Wollongong Local Planning Panel Assessment Report | 6 February 2024

WLPP No.	Item No. 2
DA No.	DA-2023/526
Proposal	Residential - construction of semi-detached dual occupancy and Subdivision - Torrens title - two (2) lots
Property	Lot 3 DP 1239971 54 High Street Thirroul
Applicant	MacCormick & Associates Architects
Responsible Team	Development Assessment and Certification - City Wide Team (NA)
Development cost	\$666 000
Lodgement date	12 July 2023
Prior WLPP meeting	Not applicable

ASSESSMENT REPORT AND RECOMMENDATION

Figure 26: Extract of ground floor plan showing rear boundary and 8m setback lines in red and second storey encroachments in yellow.

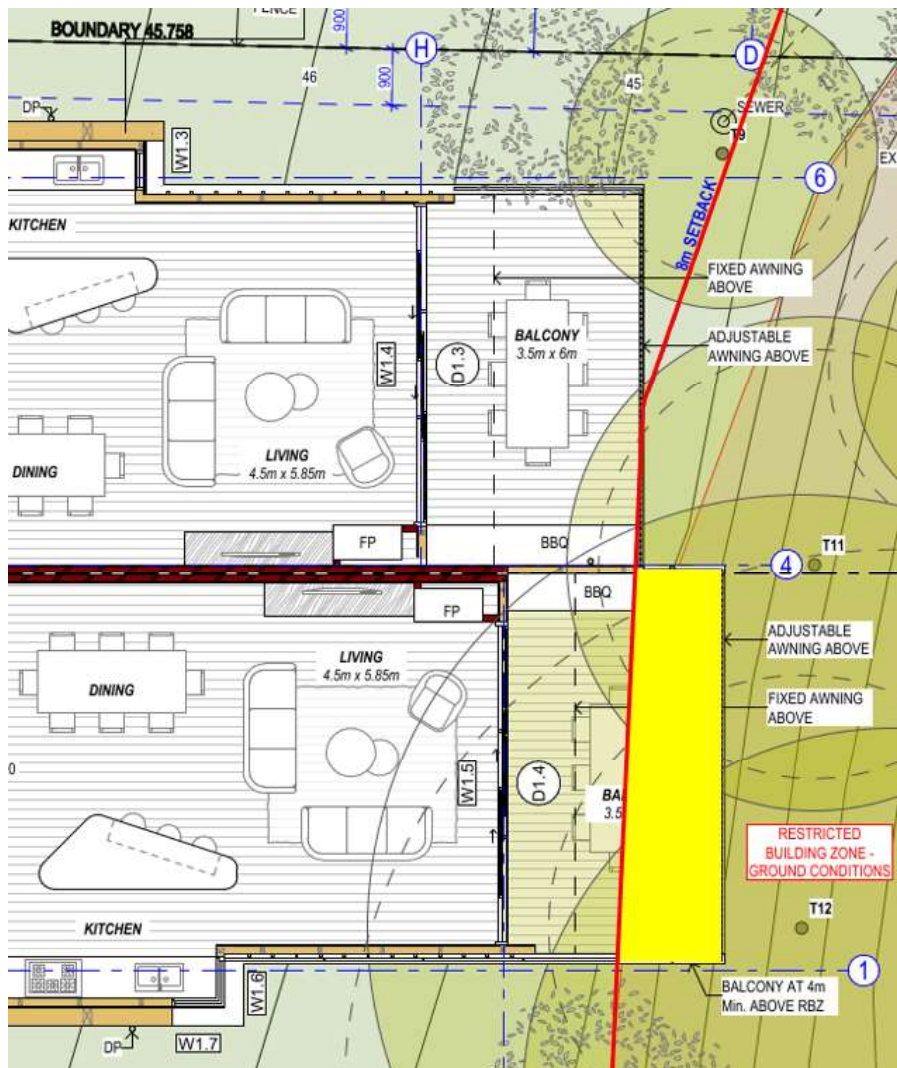
The proposed development involves the erection of an attached dual occupancy. The site slopes to the rear and the ground floor level which is designed to be close to the front boundary level becomes elevated at the rear. This fall of the site and elevation of the ground floor level at the rear provides opportunity for a lower ground floor level to be provided under part of the ground floor level. As a result, the ground floor level becomes the second storey when viewed from the rear and the 8m rear setback in Control 4.1.2.4 becomes applicable. The 8m rear setback line and the ground floor encroachment into this setback area of the proposed balconies is illustrated in **Figure 26**.

As illustrated in **Figure 26** the non-compliance relates to the rear balcony of dwelling 54B. The extent of the non-compliance varies due to the balcony not being parallel to the irregular rear boundary. The greatest point of variation occurs at the eastern most point of balcony which is setback approximately 6.3m from the rear boundary (measured perpendicular to the rear boundary).

Figure 28: Extract from Section Plan prepared by *Maccormick + Associates Architects* illustrating height of subject site relative to land to the north.

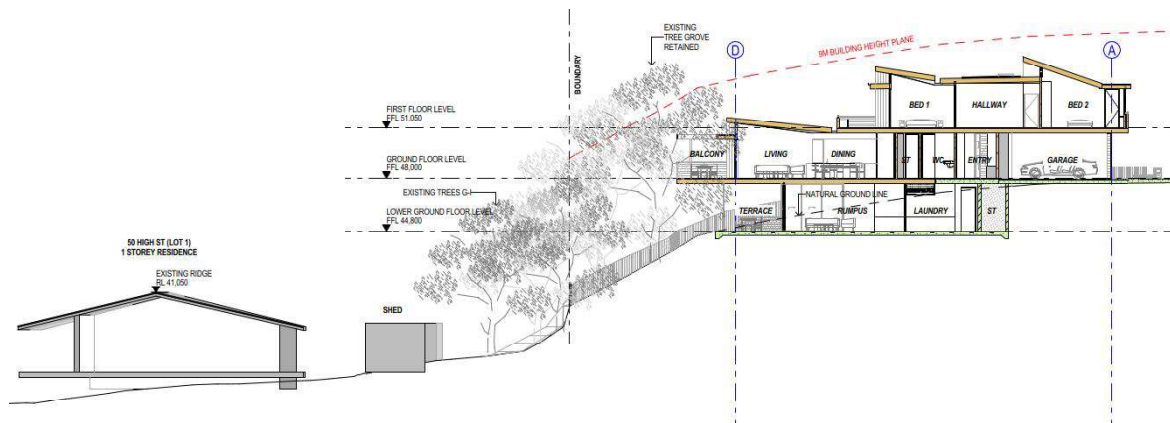
- The site falls to the rear with northern outlook towards the Illawarra Escarpment. This fall continues to the north in a manner that results in the properties to the north of the subject site having natural ground levels significantly lower than the subject site (as illustrated in

Figure 28). This elevation and outlook will result in sight lines looking out and over properties to northern rather than down toward them.

Figure 30: Extract from West Elevation Plan prepared by *Maccormick + Associates Architects* illustrating 7m height line in blue.

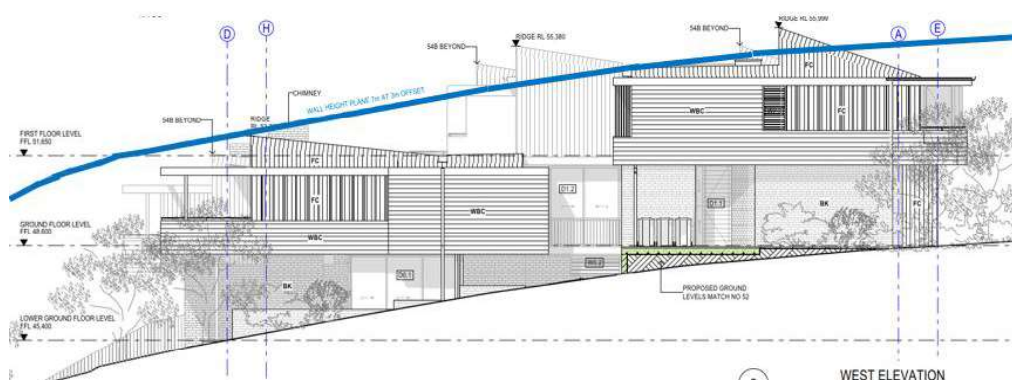
The site falls to rear and the location of floor levels reflects this topography with the first floor only being proposed on the higher portion of the site and the proposed development generally presenting as two storeys in height with the ground floor and first floor presented as the two storeys to the south (on the southern portion of the building footprint) and the ground floor and lower ground floor presenting as the two storeys to the north (on the northern portion of the building footprint). This stepping is illustrated in **Figures 29 and 30** which also illustrate how this design approach has generally contained the building below the 7m height line along the side elevations with the exception of some roof elements.

As outlined in Control 4.3.2.2 of Chapter B1 Residential Development, where walls exceed 7m in height they should be setback 3m from the side boundary. Small portions of the abovementioned roof elements are setback less than 3m from the side elevations as illustrated in **Figures 31 and 32**. Specifically, the minimum setback of these elements from the side property boundaries are 1.8m from the east and 1.2m from the west.

Figure 33: Extract of Southern Elevation Plan of proposed dual occupancy prepared by *Maccormick + Associates Architects*

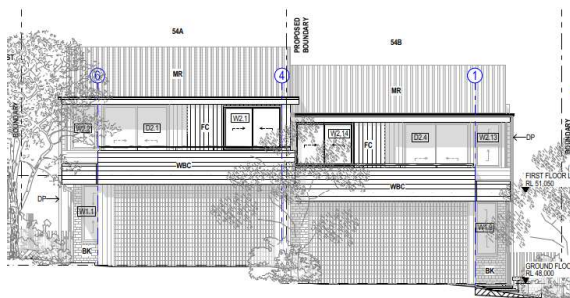
The subject site gains vehicle access from the southern boundary. This boundary has a length of 18.9m. This southern boundary of the proposed development site fronts a right of carriageway from which vehicle access can be gained. This right of carriageway does not provide for any through traffic and terminates to the east of the site in a 'Y' head. No parking is permitted within the right of carriageway and therefore all parking needs to be provided on site. As such both dual occupancy dwellings have been designed with double garages and a stacked car space resulting in two double garages being presented to the southern frontage. These garages have an external width of approximately 12.8m and exceed 50% of the width of the southern elevation which has been setback from side boundaries as illustrated in **Figure 33**.

Figure 1: Extract of Section Plan prepared by *MacCormick + Associates Architects* showing Section A through No. 54A.

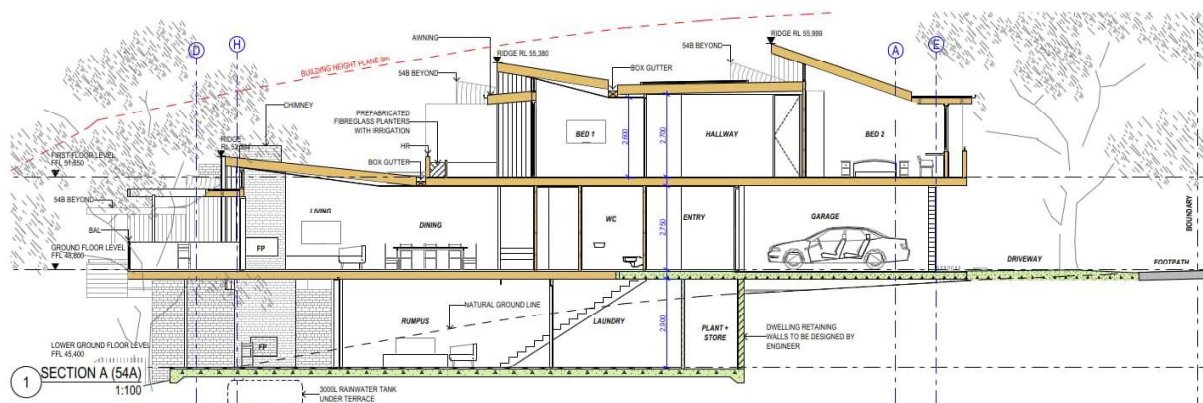
Specifically, in response to the natural fall of the site toward the rear (north), the proposed development has been designed over three different levels being the first floor, ground floor and lower ground floor. The first floor is located over the southern portion of the ground floor and is setback from the rear elevation. In this regard, the first floor terrace of each dwelling is setback from the corresponding rear northern façade of the ground floor balcony by approximately 9.7m. In contrast, the lower ground floor is located further to the north with the lower ground floor being setback from the front southern street façade by approximately 6.1m. Notwithstanding this staggering of the floor levels, some overlap of the first floor and the lower ground level occurs to enable the lift shaft to carry through to all three floor levels. Furthermore, the lower ground floor is extended adjacent to the lift to allow for a storage room/plant room.

The overlap of the first floor level with the lower ground level which results in the three storey portion is illustrated in extracts of Sections A and B prepared by *MacCormick + Associates Architects* shown in **Figures 1 and 2**.

Figure 5: Extract of Plan prepared by *MacCormick + Associates Architects* showing Section C through proposed development, the sites natural slope and the dwelling on the rear adjoining property.

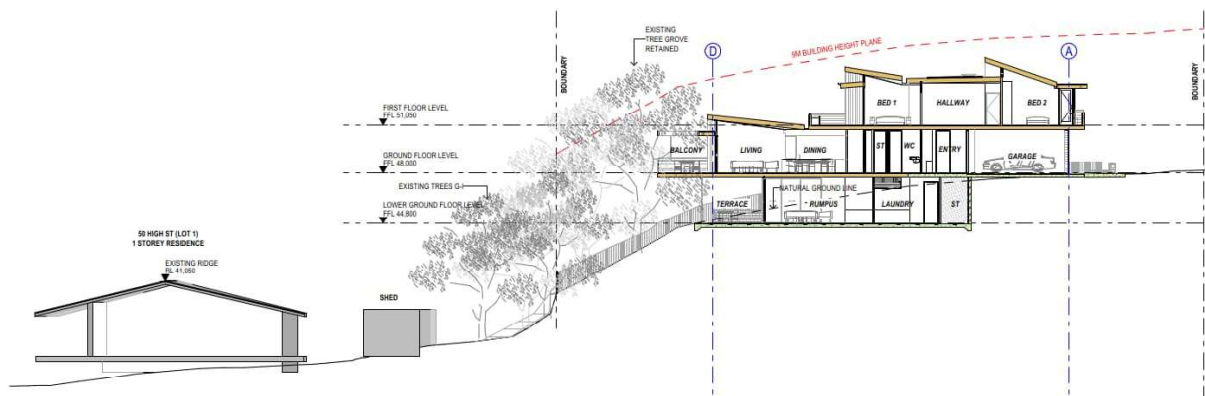
- the first floor being setback from the rear elevation;
- the change in natural ground level; and
- the existing vegetation on the subject and adjoining site and proposed vegetation within the rear setback of the subject site.

These site and design features are illustrated in an extract of a plan prepared by *MacCormick + Associates Architects* shown in **Figure 5**.

Figure 6: Extract of Ground Floor Plan prepared by *MacCormick + Associates Architects* showing location of non-compliant retaining walls along the side boundary highlighted in red and circled in yellow.

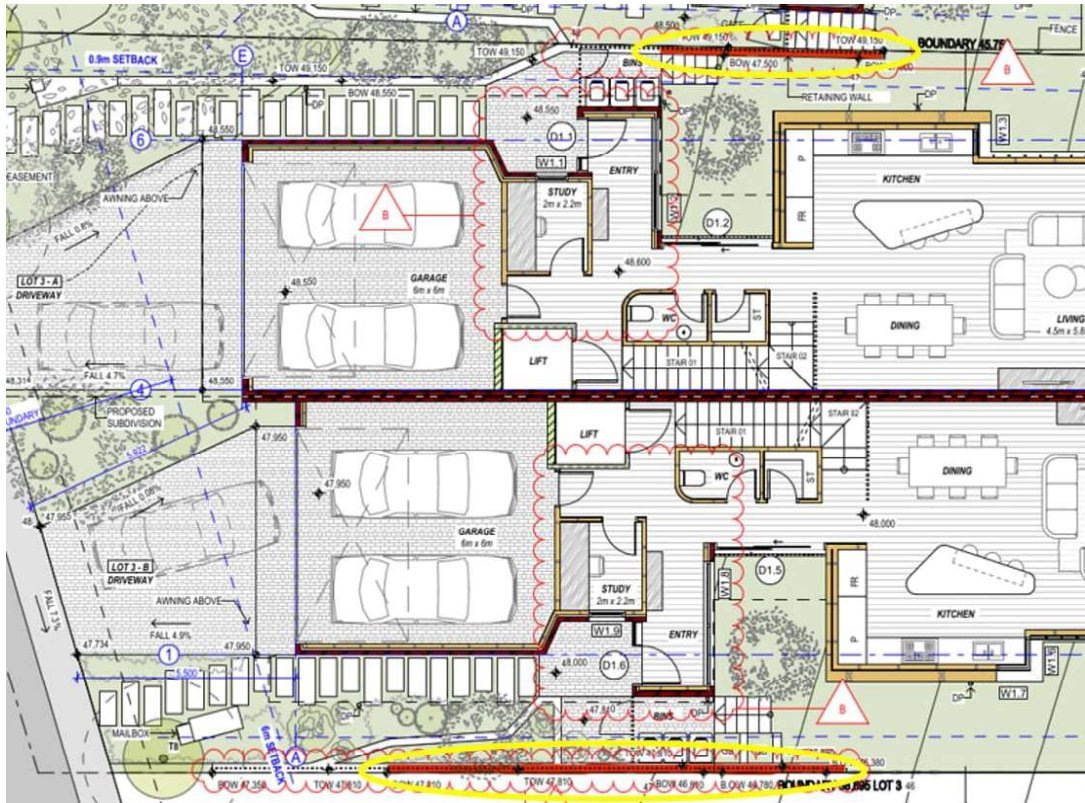
The retaining wall along the eastern side boundary reaches a maximum height of 1m. The retaining wall proposed along the western boundary is extended to the north in order to accommodate the side access stairs of the proposed development (DA-2023/527) on this western adjoining property. Due to the land continuing to fall to the north, this extension results in a maximum retaining wall height of 2.15m for this western boundary retaining wall. Although this is less than the 2.2m in Control 4.17.3.9(b), a fence is proposed atop this wall to provide for safety of those utilising the stairs and to provide privacy between the adjoining sites. In this regard, the landing at the top of the stairs is only 600mm below the top of the retaining wall height and would not in its self provide privacy between

the two landings and dwelling entry areas. These areas of non-compliance are shown in **Figure 6** (highlighted in red and circled in yellow).

Notwithstanding the non-compliance of these two side boundary retaining walls, their height is suitable for a sloping site in this locality and enables functional external access between the front and the rear of the site.

Figure 7: Extract of Ground Floor Plan prepared by *MacCormick + Associates Architects* showing location of non-compliant retaining walls along the side boundary highlighted in red and circled in yellow.

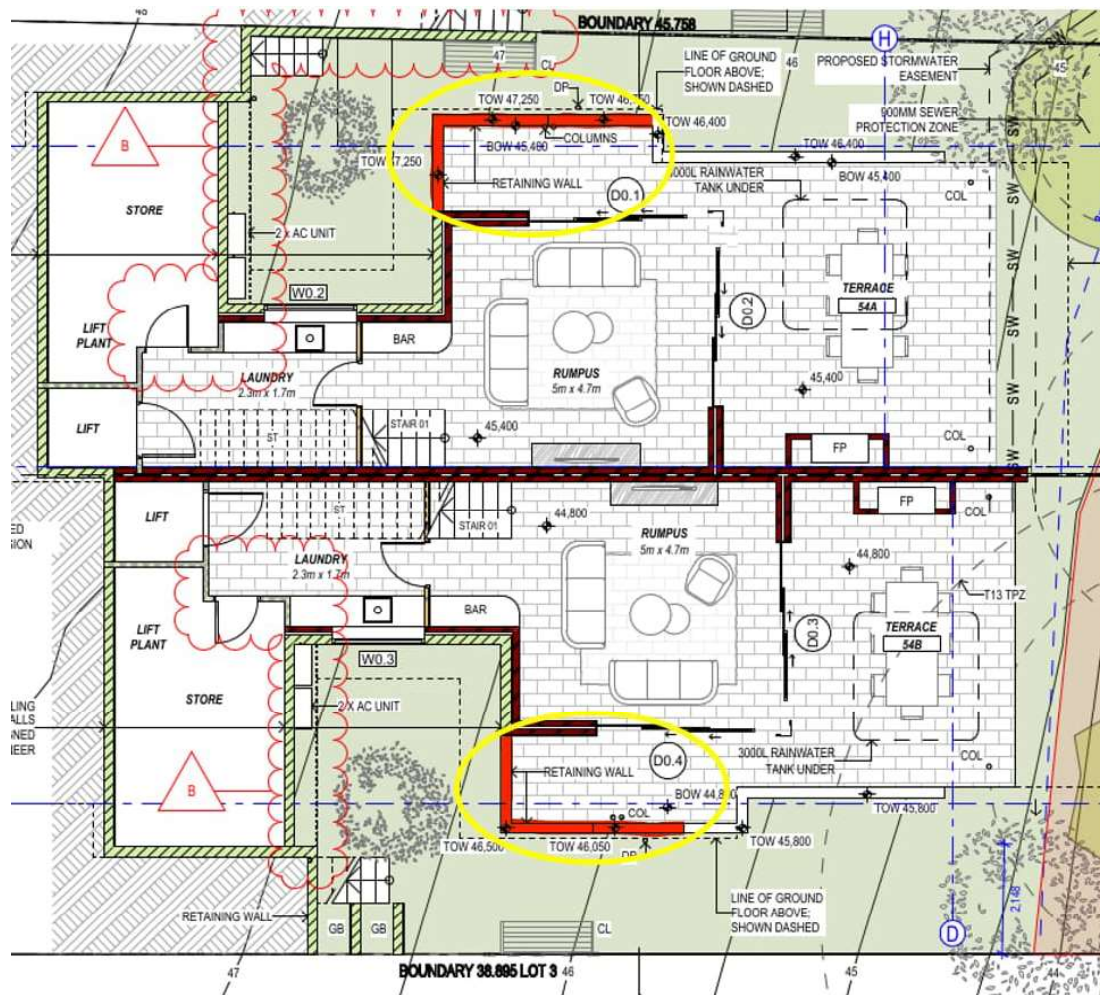
In addition to the side boundary retaining walls, retaining walls associated with the terrace area adjoining the lower ground floor rumpus room for each dual occupancy dwelling are also non-compliant. These two walls are located adjacent to the lower ground floor rumpus room of each dwelling and accommodates cut into the site to improve connectivity between the rumpus rooms and the adjoining terrace areas and ventilation opportunities for the rumpus rooms. These retaining walls are stepped and have a maximum height of 1.85m for Dwelling 54A and 1.7m for Dwelling 54B. The locations of these walls are shown in **Figure 7**.

Notwithstanding the non-compliance of these two retaining walls, their height respective to the adjoining landscaped areas and their setback from boundaries ensure that they do not result in any adverse impacts and are considered suitable for a sloping site in this locality.

Figure 9: Extract of West / Street Elevation with non-compliant retaining wall circled in yellow.

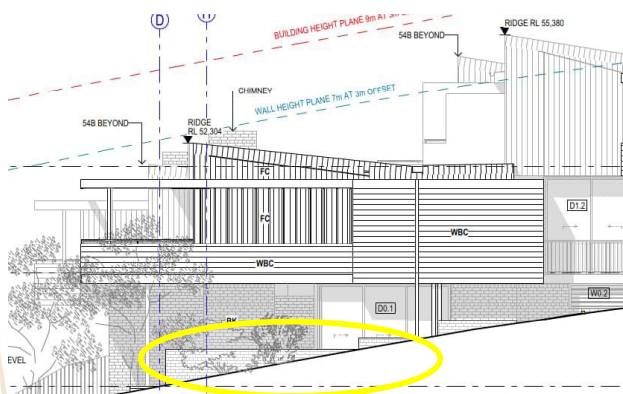
With regard, to the retaining walls adjacent to the lower ground floor rumpus rooms, these walls are predominately below natural ground level, are setback approximately 1.6m from the western side boundary and approximately 2.4m from the eastern side boundary and are not visible from the right of carriageway. The low visual impact of these walls is illustrated in **Figures 9 and 10**.
